## MATERIALS LICENSE

Amendment No. 4

Licensee		
1. Roanoke Memorial Hospital Nuclear Pharmacy Services	In accordance with letter dated November 19, 1992	
2. Belleview at Jefferson Street Roanoke, Virginia 24033	3. License number 45-01291-04MD is amended in its entirety to read as follows:

RE: Response to request for additional amendment information

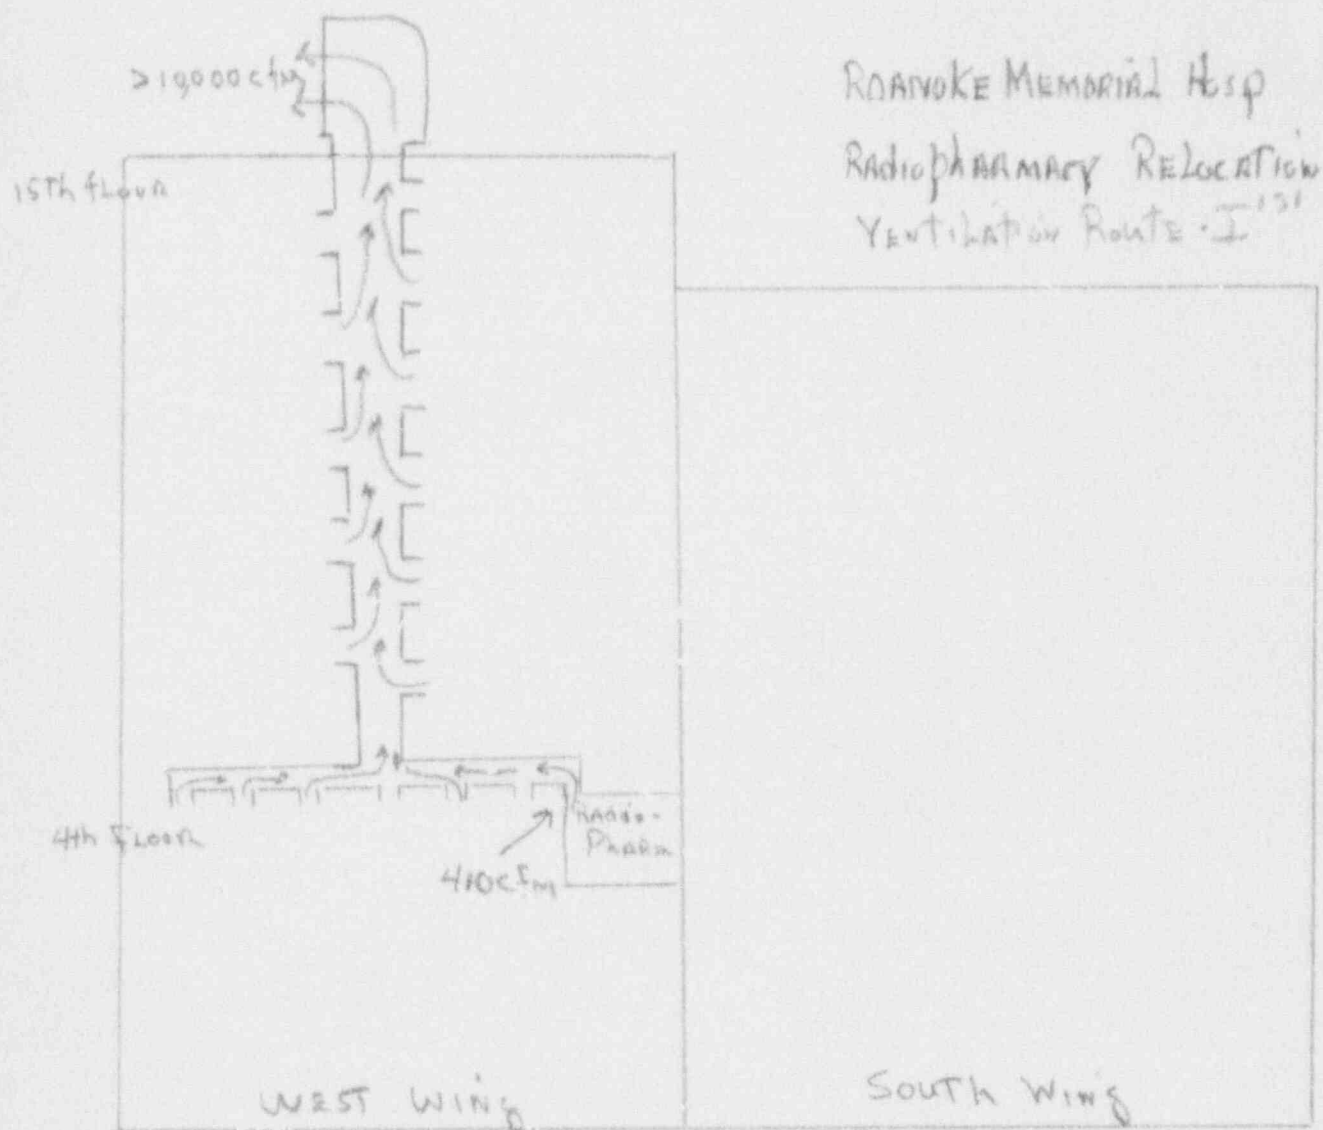
The following is in response to your request for additional information on our ventilation system for our proposed Radiopharmacy site.

The proposed site is located on the 4th floor (Suite 420) of the West Wing of Roanoke Memorial Hospitals. The radioiodine fume hood would be directly vented from this 4th floor location at a minimum of 80 cubic feet per minute as follows. This air be vented directly to a closed duct system, which has a present air flow rate of 410 cfm at the face of a 6" x 20" air duct. Air would be vented laterally along this floor collecting air from other rooms along the hallway. The 410 cfm is measured at the end of this duct system, and would be considered the minimum flow rate.

As air flows along this lateral duct work, the actual air flow increases as it is turned vertically and vents directly out a ventilator located on the roof above the 15th floor. At the point where the air actually leaves the building site, the minimum air flow is in excess of 10,000 cfm at the point of exit.

I have attached a diagram which I hope helps describe the ventilation system as it presently exists.

Exhaust Ventilator Environment  
Riverside Memorial Hosp 1/5/93

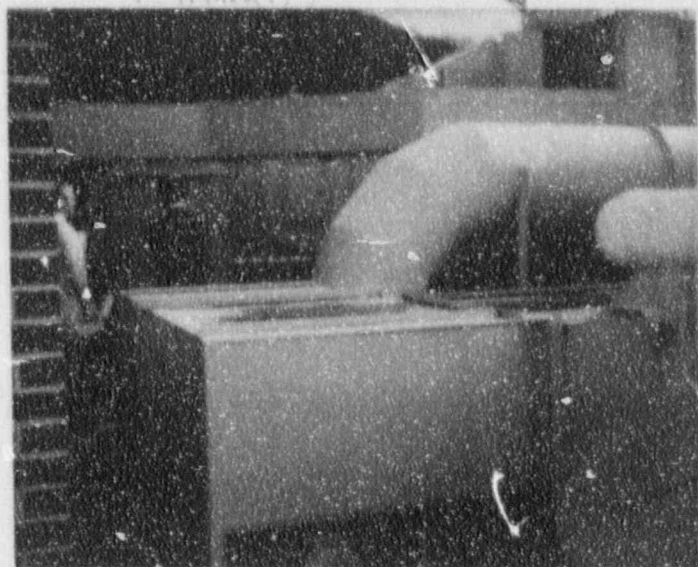
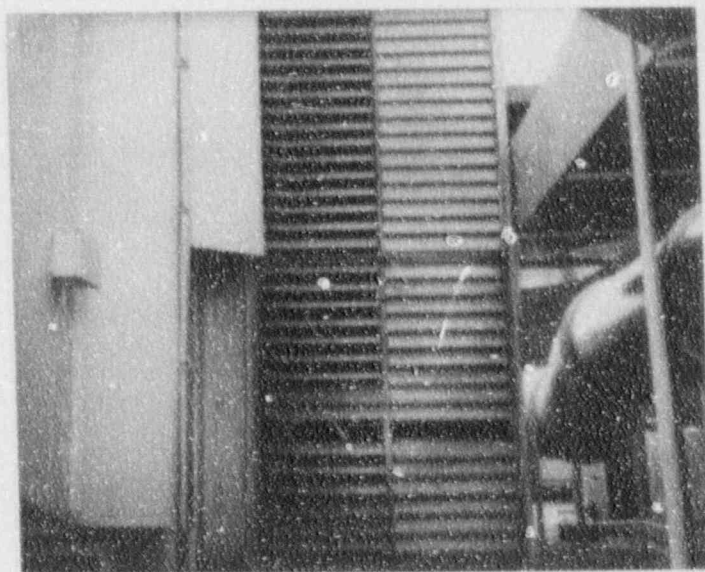
Discussed that add'l info needed on furnace hood & exhaust system w/ appropriate relocation: Stack ht., distance from fresh air intake & vent, windows; location of filter & blower - method & freq of in place filter testing; min. face velocity - method & freq of checks.

1. The radioiodine fume hood is vented directly from our 4th floor location at 80 cubic feet per minute to a sewage vent exhibiting an air flow of about 1000 cubic feet per minute and finally to a heat exchanger ventilator located on the 15th floor which runs constantly at greater than 10,000 cubic feet per minute. The minimum height of this ventilator above the roof is 2 feet to a maximum height of approximately 9 feet. Its location is on the highest roof level of the building, and is not routinely occupied by personnel. Photos enclosed are of the ventilator exhaust area, and the general ventilator environment.
